EEG-56

**UNRESOLVED ISSUES FOR THE DISPOSAL OF
REMOTE-HANDLED TRANSURANIC WASTE IN
THE WASTE ISOLATION PILOT PLANT**

Matthew K. Silva
Robert H. Neill

September 1994

Fig. 1 Estimated RH TRU inventory for emplacement in WIPP. Estimates based on U.S. DOE Integrated Data Base (U.S. DOE, 1986, 1987, 1988c, 1989, 1990d, 1991d, 1992) except where noted.

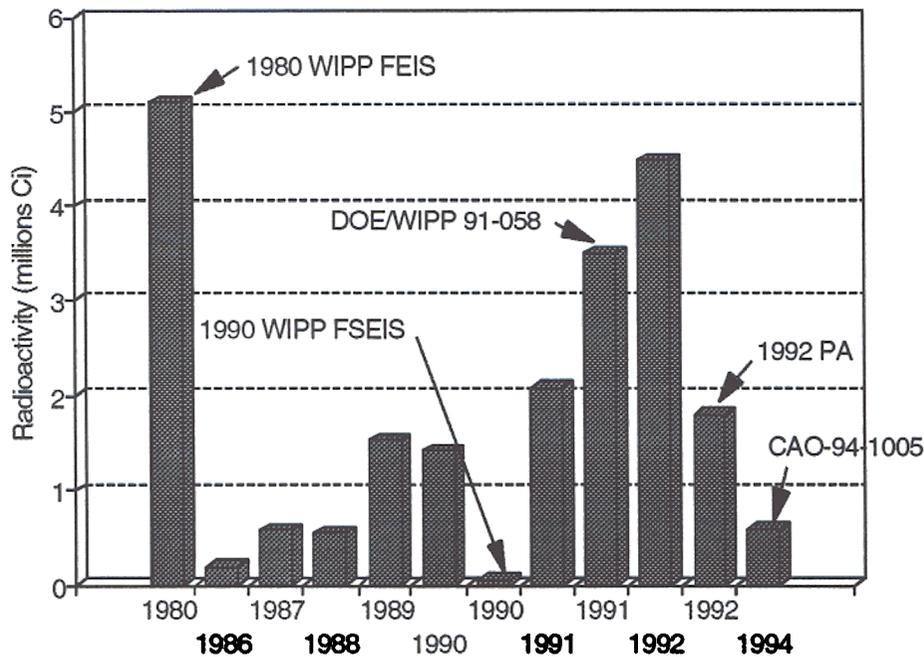
Table 1 shows, in detail, the disparity between the RH TRU radionuclide inventory from the 1994 DOE Baseline Inventory Report (U.S. DOE, 1994b, section 5.4 and Table 5-3) and the 1994 DOE Compliance Status Report (U.S. DOE, 1994c, Section 4.1.5 and Table 4-4). The 1994 DOE Baseline Inventory Report² was based on the 1993 IDB for reporting data. The 1994 Compliance Status Report gives the RH TRU inventory "assumed" by the 1992 performance assessment effort (U.S. DOE, 1994c, sec. 4.1.5). That inventory relies on the data call for the 1991 IDB (U.S. DOE, 1991d) for stored and future generated waste (Peterson, 1992, p. A-135-140). The radioactive daughter of Sr-90, which is Y-90,

should have an identical number of curies shown since the radioactivity of this much shorter half life daughter is equal to the parent in secular equilibrium. Hence the PA calculations should include 57,000 curies of Y-90.

The portrayal of the RH TRU inventory as "assumed" by the 1992 PA (U.S. DOE, 1994c, sec. 4.1.5) must be viewed with caution. It appears the RH TRU inventory was not actually included in the 1992 PA transport calculations. Rather, the RH TRU was included only in the cuttings release to the surface. The 1992 PA transport calculations were limited to nine radionuclides from the CH TRU waste inventory (Sandia, 1992, vol. 3, section 3.3.3).
